ADDENDUM NO. 2

**Three Rivers Community Schools – Three Rivers Middle School Additions and
Renovation**

SHEET CLARIFICATIONS / REVISIONS

CONSTRUCTION PHASING
PLAN

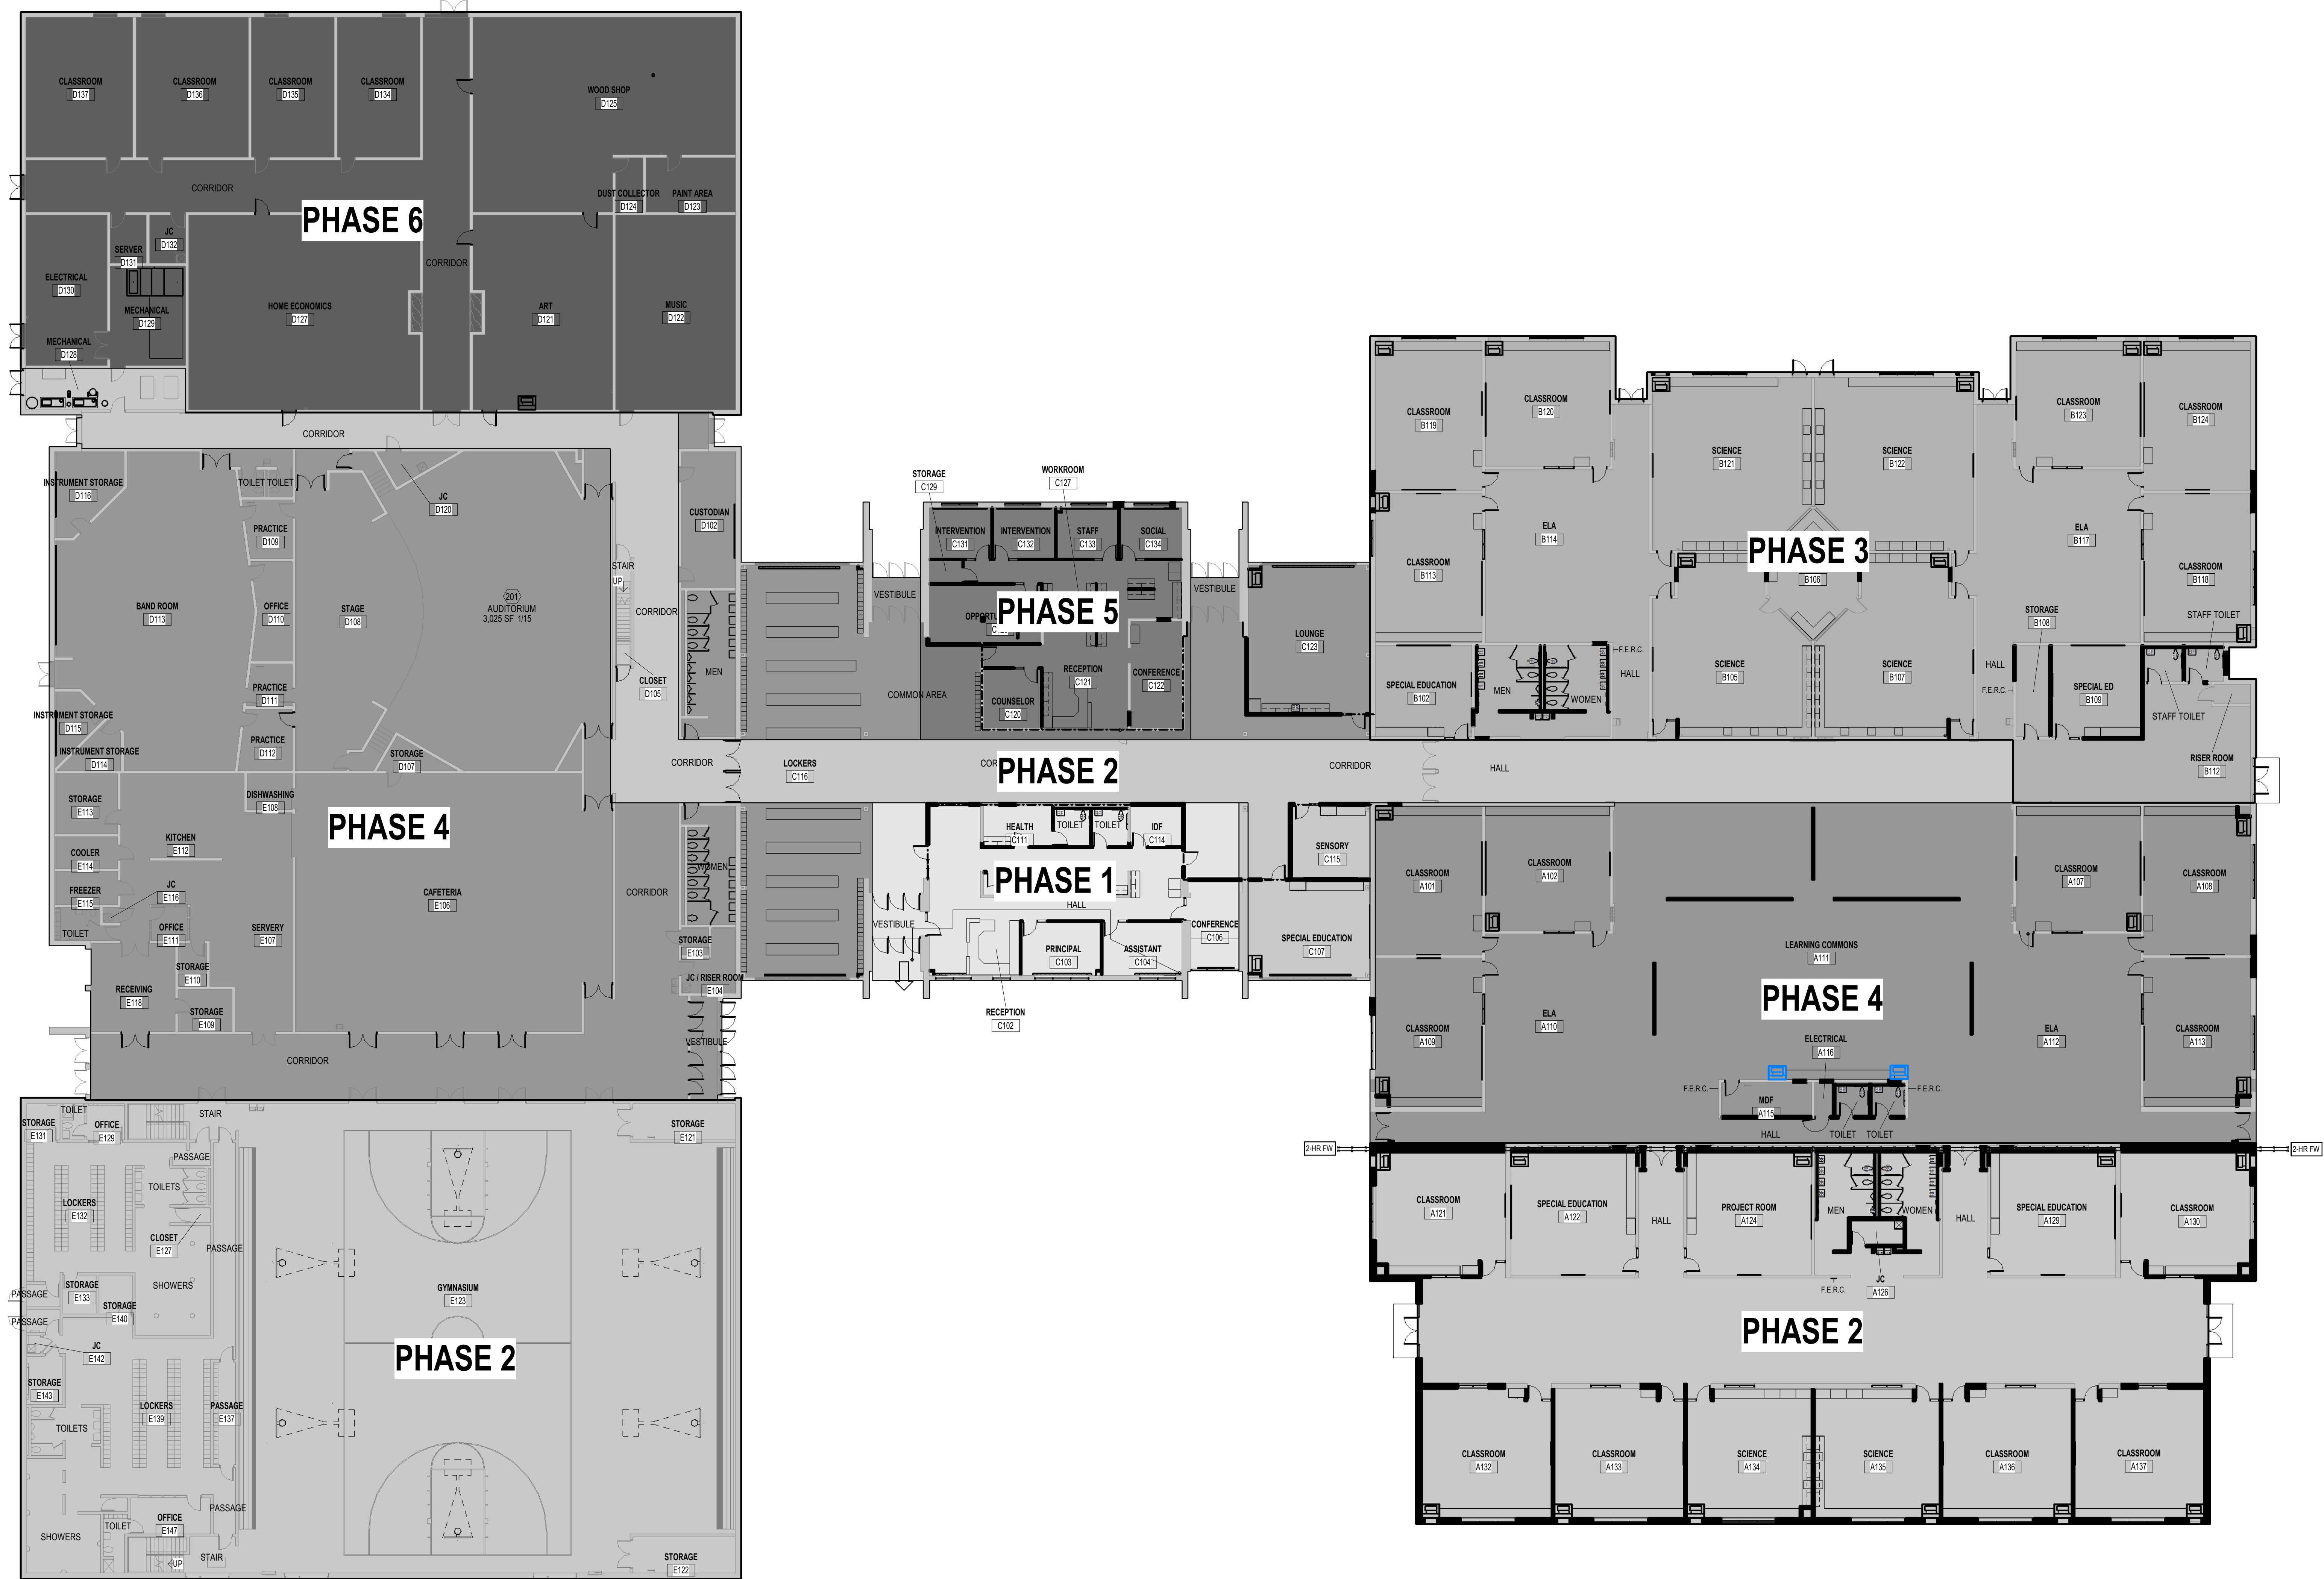
ITEM NO. 5 **SHEET G2.01 – CONSTRUCTION PHASING PLAN (REISSUED)**

Revised construction phasing plan per Skillman updates.

UNIT 'A' FOUNDATION PLAN

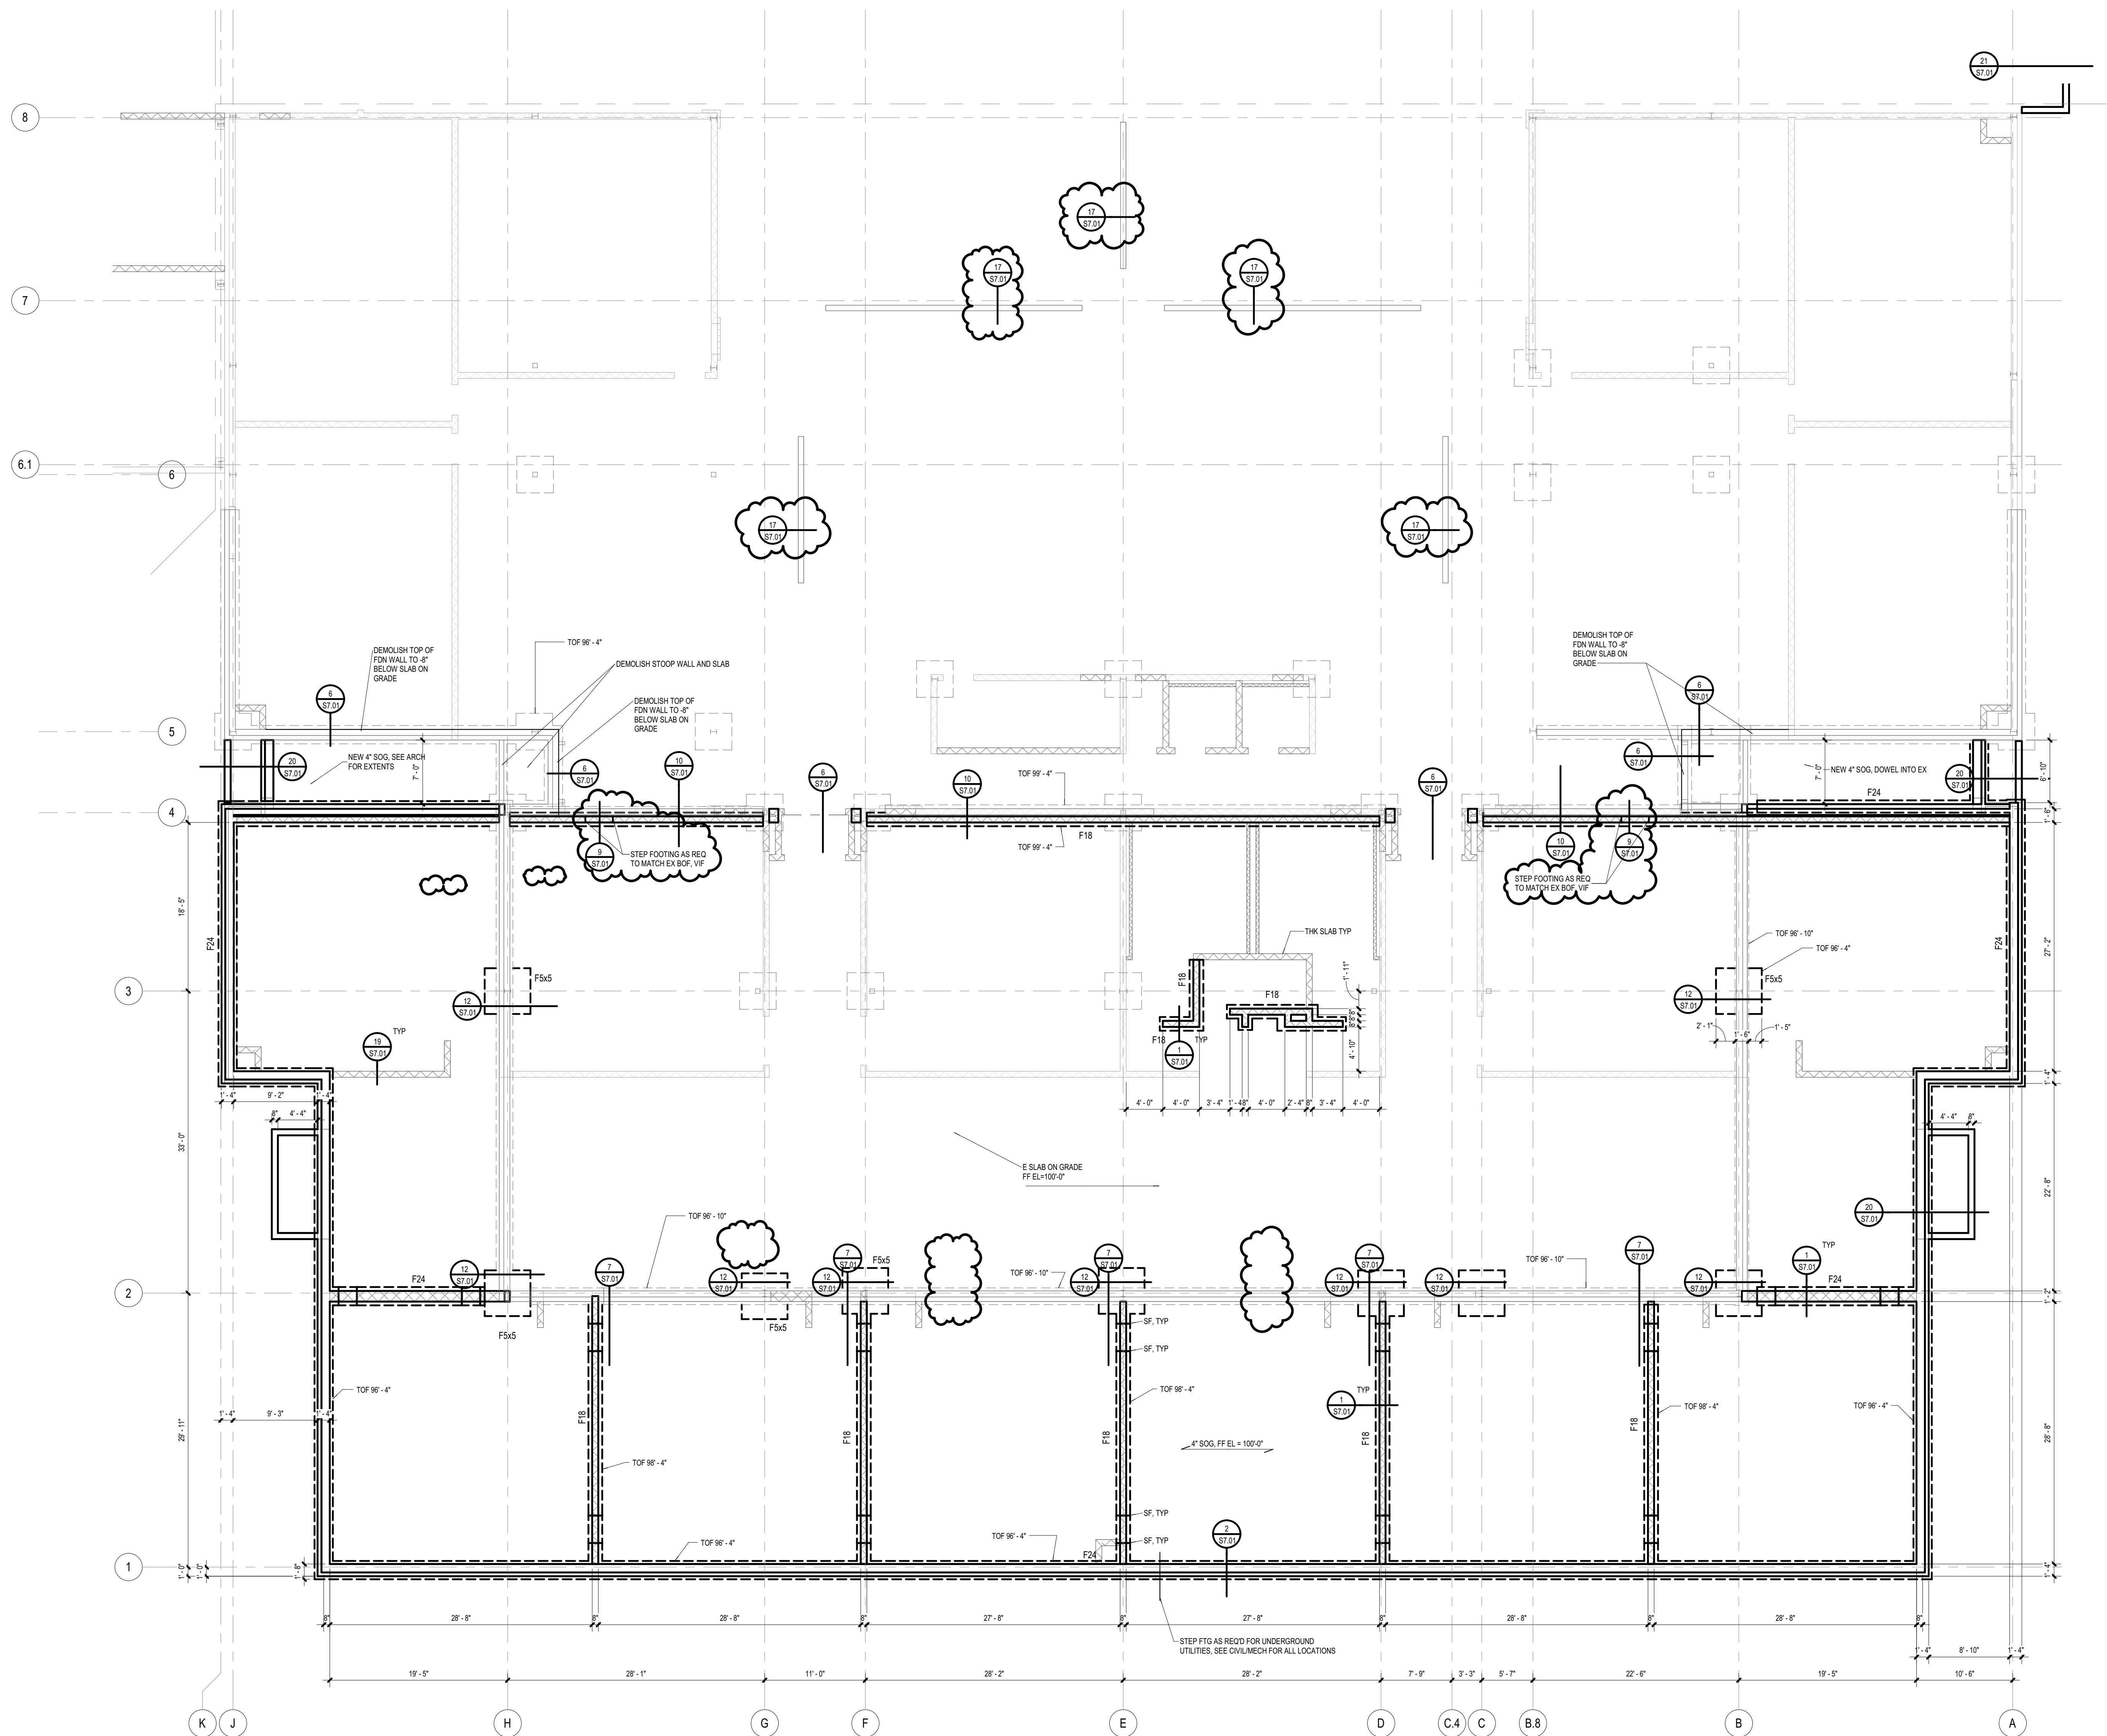
ITEM NO. 9 **SHEET S2.1A - UNIT 'A' FOUNDATION PLAN (REISSUED)**

- A. Moved section cuts for Detail 9/S7.01 from line 2 to line 4.
- B. Added section cuts for Detail 17/S7.01
- C. Added stepped footing as required.
- D. Removed existing top of footing elevations callouts.

UNIT 'C' FOUNDATION PLAN
1/8" = 1'-0"

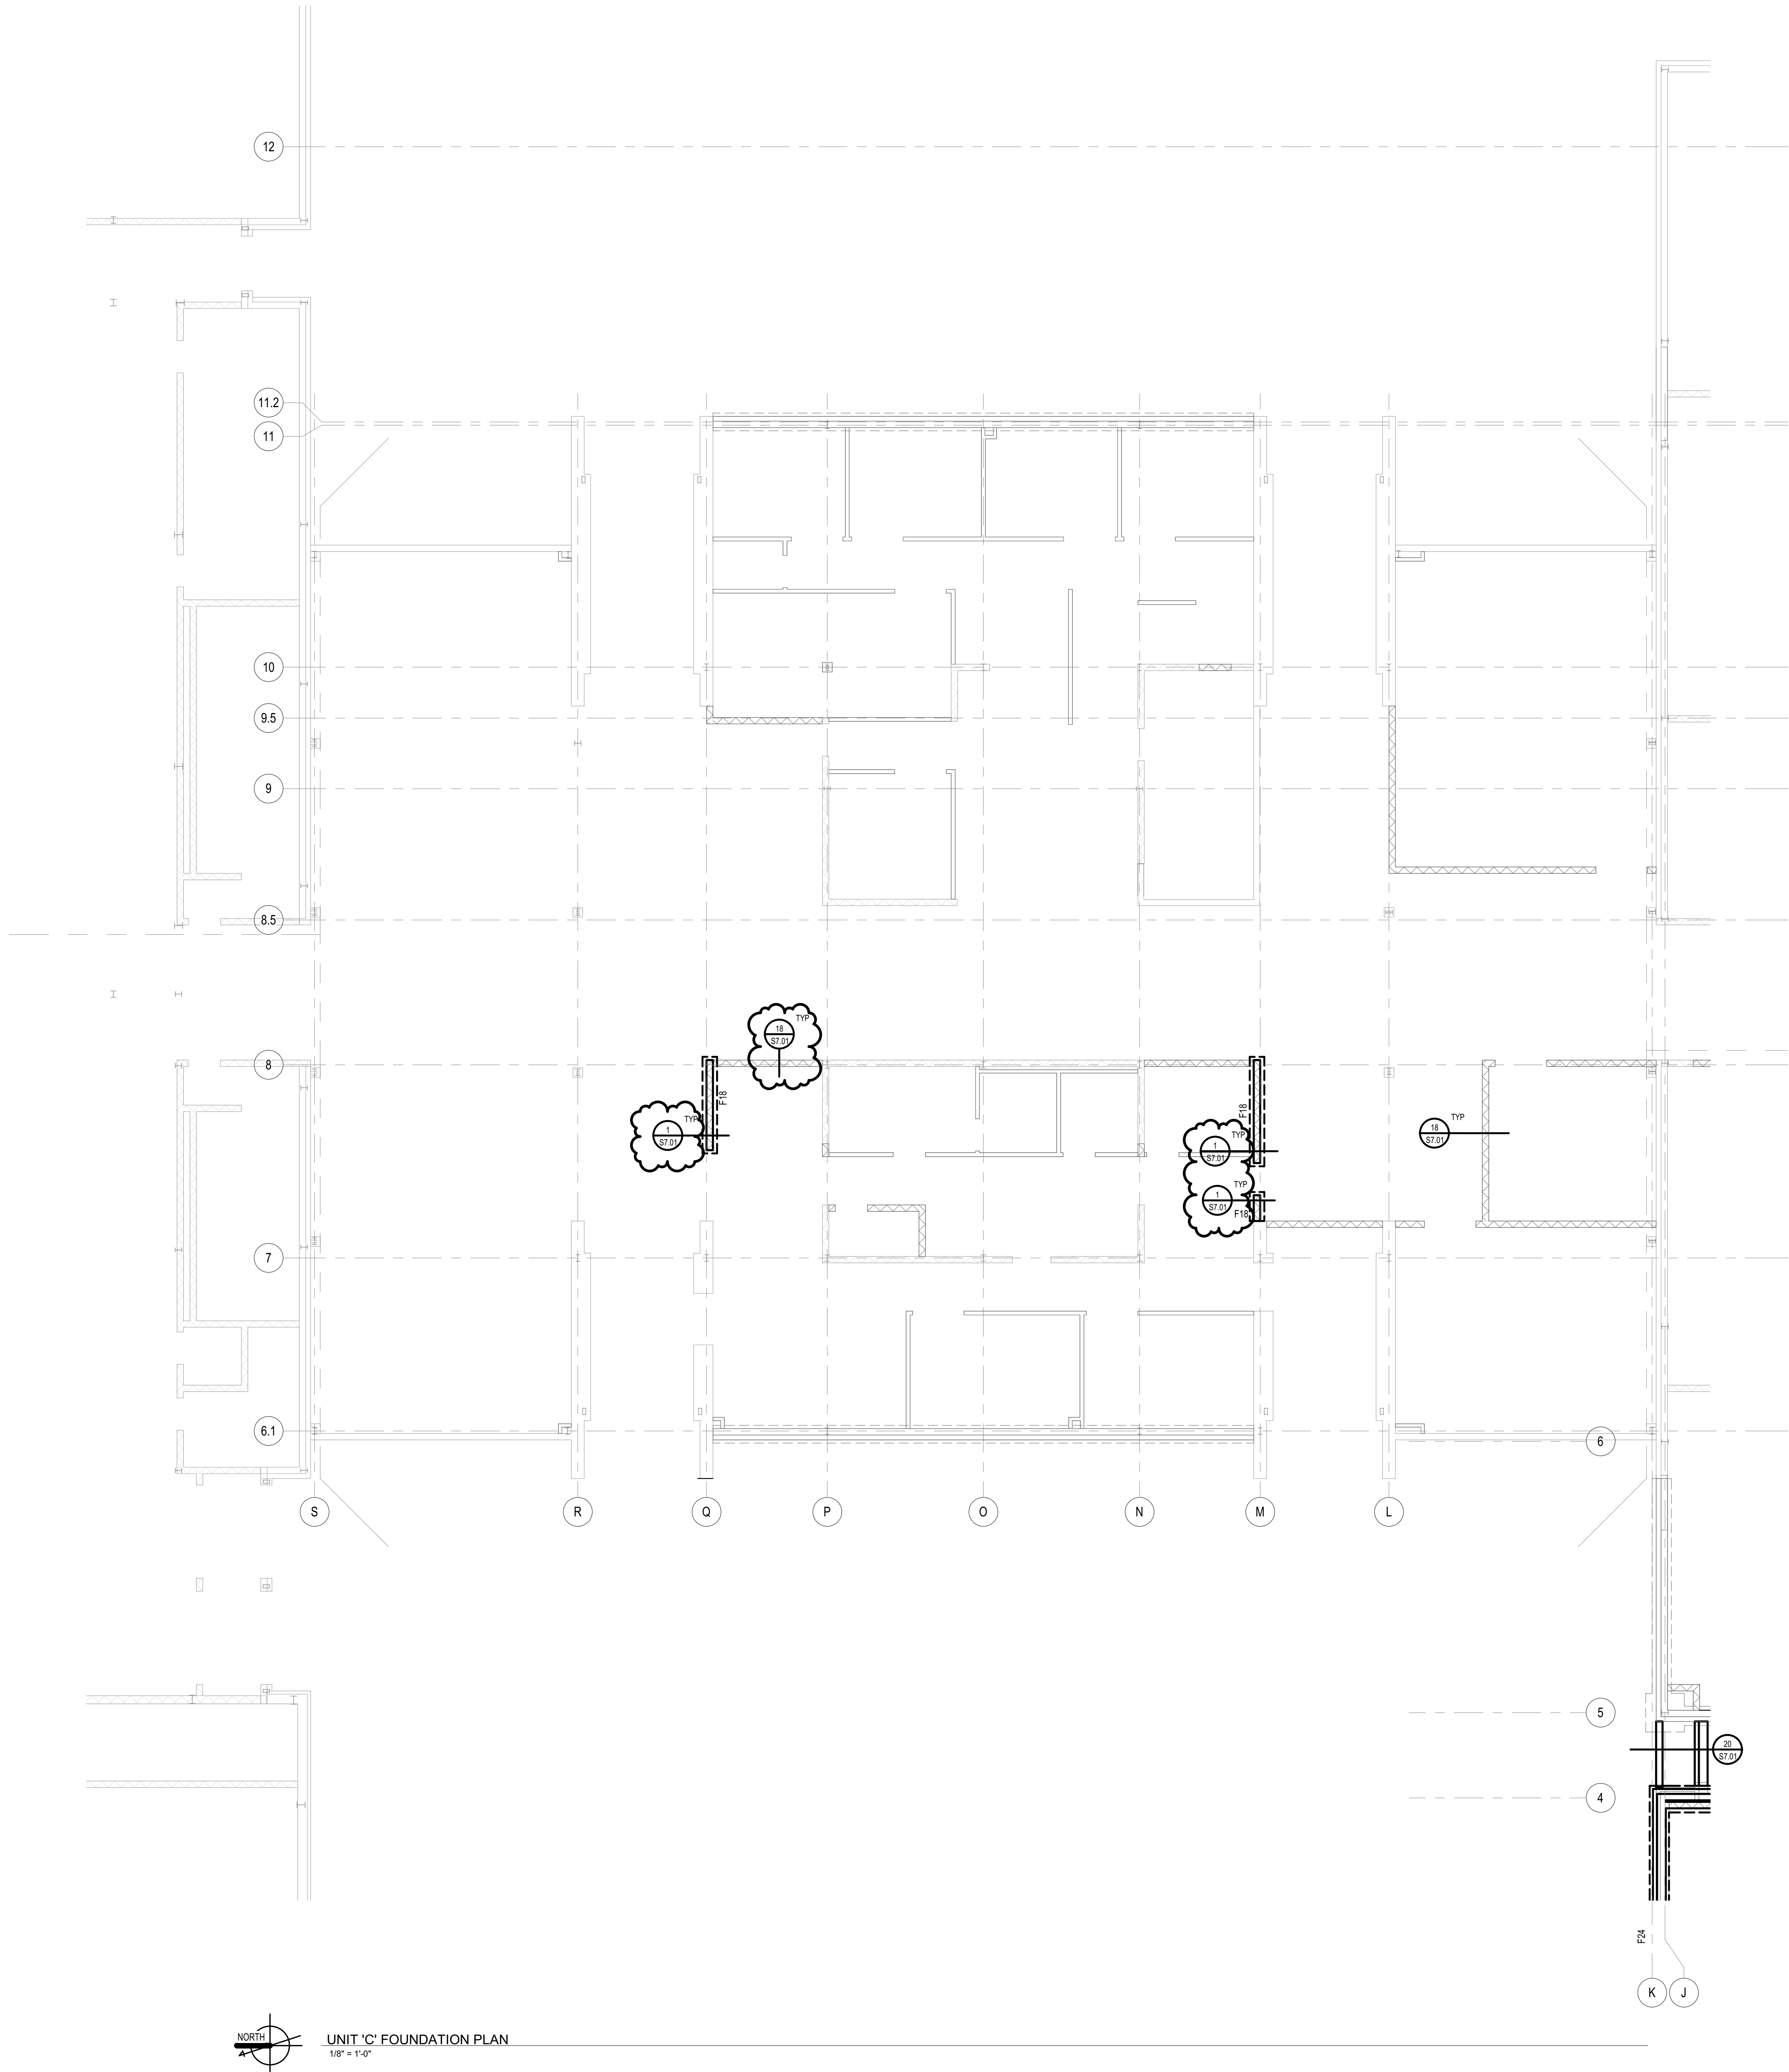
ITEM NO. 10 **SHEET S2.1C - UNIT 'C' FOUNDATION PLAN (REISSUED)**

- A. Added section cuts for Details 1 and 18/S7.01.
- B. Added footing size.
